MEMO

Subject: 2033-4th Avenue, MUP #3038668-LU – Solid Waste Collection and Alley Operations

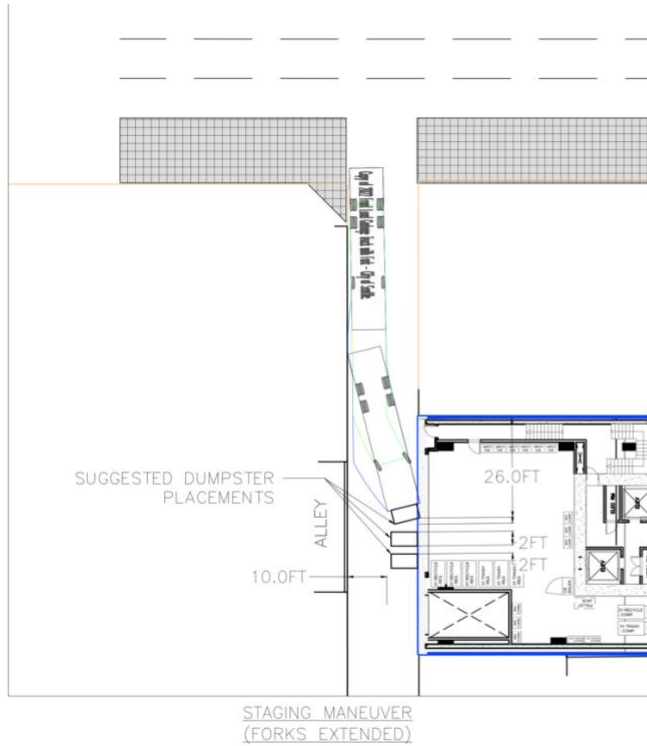
- 3) Neighboring alley properties and users will be affected by the required perpendicular orientation of dumpsters that narrows the alley to about 10 feet, making it difficult, if not impossible, for any but the smallest vehicles to move through the alley. With four dumpster collections per week plus another collection for food waste bins, this will be a near daily occurrence. Vehicles will have to navigate around the project's dumpsters and then around those from adjacent buildings, including the YMCA. The result will be a serpentine path of travel for one vehicle at a time.

are staged means that the alley will effectively become a narrow one-lane operation for two-way traffic over about half its length. How will drivers entering from Lenora know that another vehicle is already heading north to the street? And how will opposing drivers negotiate who goes first? That negotiation significantly increases the possibility of entering vehicles reversing out of the alley, or of vehicles reversing long distances in the alley's narrowest sections. Reversing out of an alley is not a legal maneuver, but drivers can be expected to do so in order to avoid conflict with other vehicles, a conflict created by the project's solid waste collection scheme. Even though the project will deed 2 feet of right-of-way per code to create an eventual 20-foot wide alley, it will not be enough to avoid this type of conflict.

- 1) The approved dumpster staging plan conflicts with use of the loading bay since the dumpsters would significantly overlap the loading bay and hinder its use. While the applicant has not shown loading bay maneuvers with dumpsters staged in the alley, the approved solid waste plan drawings and the loading bay access analysis drawings submitted to the Design Review Board (dated August 22, 2022) reveal the conflict, as shown below. The August 22 drawings show that the delivery truck (SU-30) needs the full width of the alley and almost the full width of the bay to maneuver in and out, as does the U-Haul 20' truck. Neither truck could enter or depart the loading bay when dumpsters are staged in the alley.
